## **9025 - M4 J23a Magor Interchange Temporary Signals Combined Stage 1 & 2 Road Safety Audit**

**9025-M4 J23a Magor Interchange Temporary  
Signals  
Combined Stage 1 & 2 Road Safety Audit**

| Scheme Reference:   | 25/SW/CSI/005                       | Programme: | CSI |

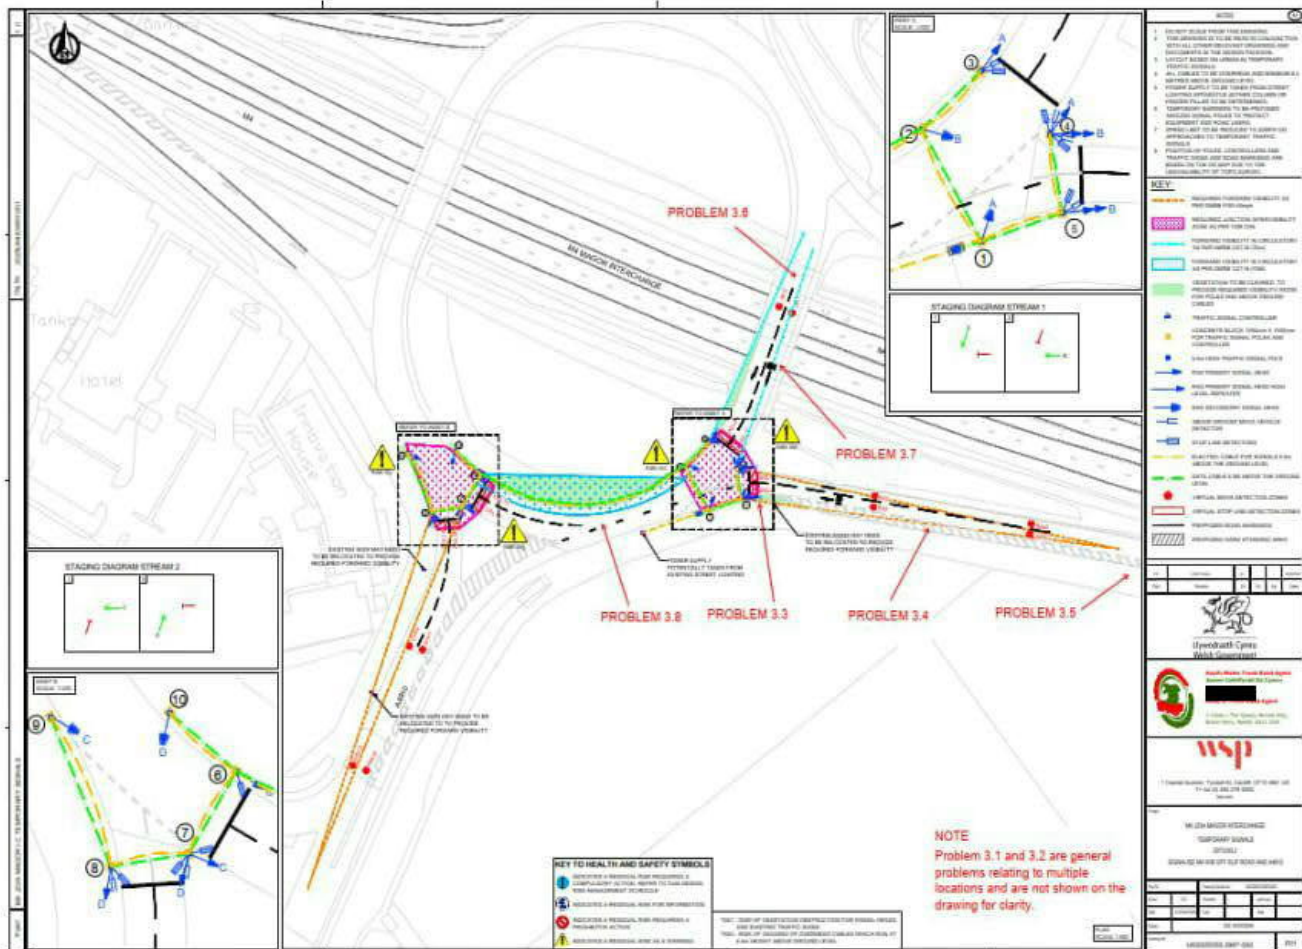
| <b>Location:</b>                                                                                                                                                                                                                                                                                                                                                                                                                                                                                                 | Options 1 and 2                                       |                                                                                                                                     |
| <b>Summary:</b>                                                                                                                                                                                                                                                                                                                                                                                                                                                                                                  | <b>Lack of carriageway width for larger vehicles.</b> | <b>Recommendation</b>                                                                                                               |
| On the westbound off slip road approach to the roundabout the carriageway width narrows to 7m in close proximity to the stop line. With the increase in heavy vehicle movements on this approach, if two larger vehicles approach the signals side by side, they may be a potential for side impact collisions or collisions with adjacent street furniture including temporary signals. There is also visible evidence of adjacent verges being overrun by traffic indicating that these manoeuvres take place. |                                                       | It is recommended that swept path analysis is undertaken, and the approach is modified if necessary to accommodate larger vehicles. |

| <b>Location:</b>                                                                                                                                                                                                                                                                                                                                                                                                                                                           | Options 1 and 2                            |                                                                            |
| <b>Summary:</b>                                                                                                                                                                                                                                                                                                                                                                                                                                                            | <b>Lack of information for road users.</b> | <b>Recommendation</b>                                                      |
| On the westbound off slip road approach to the roundabout the adjacent hard shoulder area is marked with hatched road markings, with the road markings being barely visible. As a result, vehicles may choose to park in the hard shoulder (as observed during the site visit). Parked vehicles, particularly larger side vehicles may restrict forward visibility towards the temporary signals leading to late recognition of the signals and rear end shunt collisions. |                                            | It is recommended to reapply the hatch road markings in the hard shoulder. |

| <b>Location:</b>                                                                                                                                                                                                                                                                                                                                                                                                                                                                                                       | Options 1 and 2                                     |                                                                                                                                                                                                                                                                                                                   |
| <b>Summary:</b>                                                                                                                                                                                                                                                                                                                                                                                                                                                                                                        | Inappropriate speeds approaching temporary signals. | <b>Recommendation</b>                                                                                                                                                                                                                                                                                             |
| <p>It is not clear precisely where terminal 40mph signs will be positioned on the westbound off slip road approach. Traffic approaches the interchange on the off-slip road from the national speed limit and if the speed limit reduces to 40mph too close to the signals, it will unlikely slow down the traffic sufficiently before the junction. The collision records demonstrate a concerning pattern with 4 collisions on this approach in 5 years. This arrangement may lead to rear end shunt collisions.</p> |                                                     | <p>It is recommended that the temporary 40mph terminal signs should be positioned further back from the traffic signals, prior to the gantry to give motorists more time to slow down on the approach to the signals. In addition, warning signs of traffic signal ahead/queuing vehicles should be provided.</p> |

| <b>Location:</b>                                                                                                                                                                                                                                        | Options 1 and 2                                                                     |                                                                                                                                                                                                                                                                                                                                           |
| <b>Summary:</b>                                                                                                                                                                                                                                         | Lack of forward visibility towards vehicles queuing on the circulatory carriageway. | <b>Recommendation</b>                                                                                                                                                                                                                                                                                                                     |
| <p>Traffic queues forming on the circulatory carriageway back from the temporary traffic signals may lead to rear end shunt collisions due to the road curvature and vegetation in the offside verge restricting forward visibility to the signals.</p> |                                                                                     | <p>It is recommended that a mean maximum length of traffic queue should be calculated on the circulatory carriageway approach to the proposed signals and forward visibility toward the end of the queue should be cleared. In addition, warning signs of traffic signal ahead/queuing vehicles should be provided on the roundabout.</p> |

| <b>Location:</b>                                                                                                                                                                                                                                                                                                                                                                                                                                                                                                    | Options 1 and 2                     |                                                                                                                     |
| <b>Summary:</b>                                                                                                                                                                                                                                                                                                                                                                                                                                                                                                     | Lack of information for road users. | <b>Recommendation</b>                                                                                               |
| On the eastern roundabout circulatory carriageway there is no direction signing provided showing route A4810, whilst there is associated road markings provided for this destination. Queueing traffic may cover the worded road markings resulting in vehicles taking incorrect lanes when exiting towards the A4810. In the worst case, road users not familiar with the area may miss the information shown on the road markings and undertake sudden lane changing manoeuvres leading to side swipe collisions. |                                     | It is recommended to provide a wicket type sign incorporating the A4810 destination on the circulatory carriageway. |

Option 2

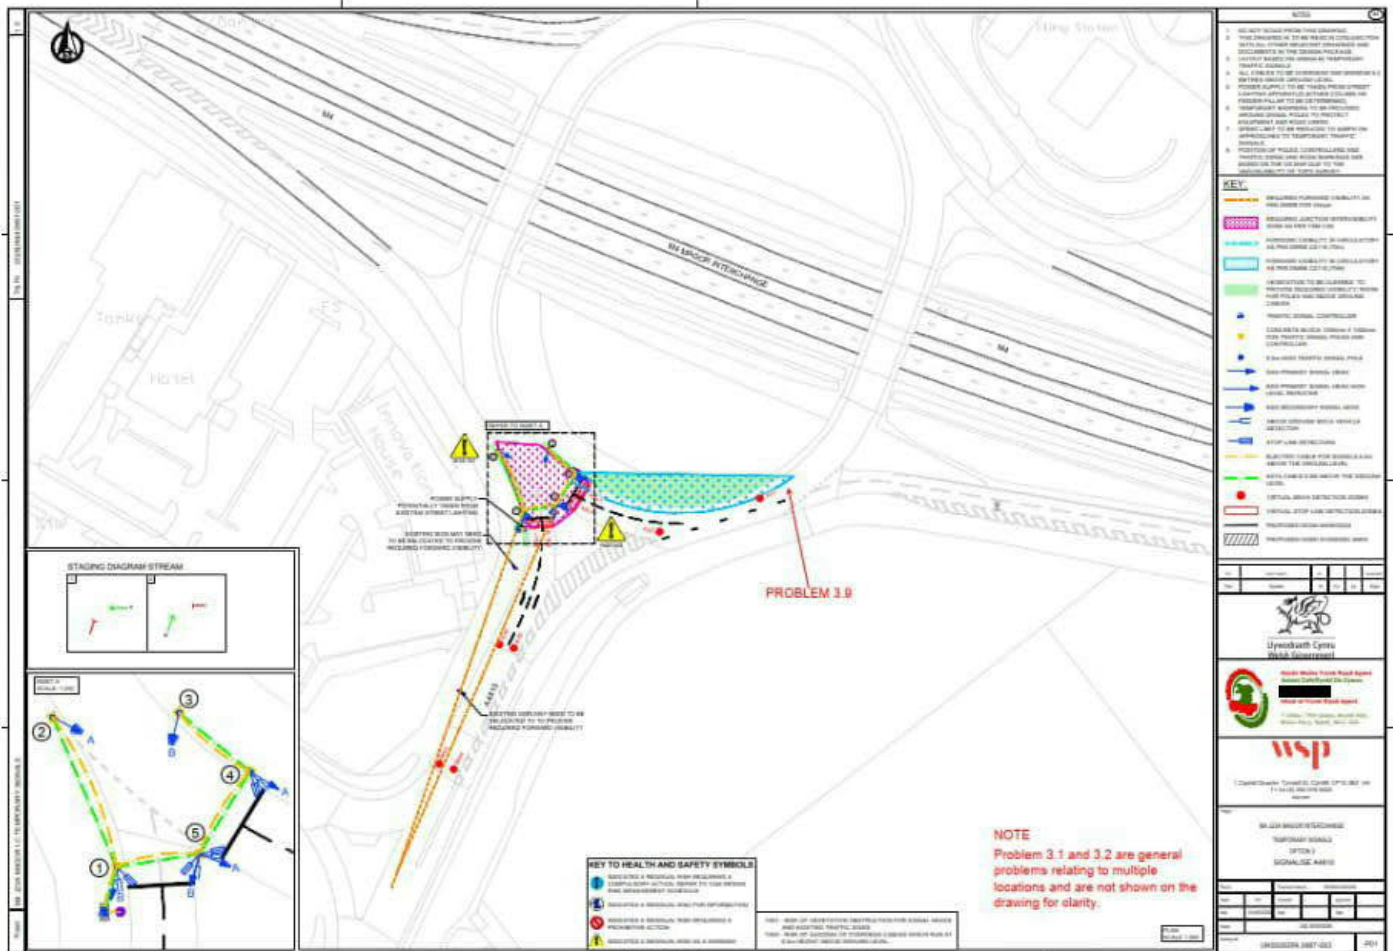
| <b>Location:</b>                                                                                                                                                                                                                                                        | Option 2                              |                                                    |
| <b>Summary:</b>                                                                                                                                                                                                                                                         | Traffic queuing leading to conflicts. | <b>Recommendation</b>                              |
| No MOVA detection zones are shown on the circulatory carriageway on the approach to the traffic signal junction with the A4810 entry. Traffic queuing at the red signal for stage C may block the exit to the A4810 leading to inappropriate manoeuvres and collisions. |                                       | It is recommended to provide MOVA detection zones. |
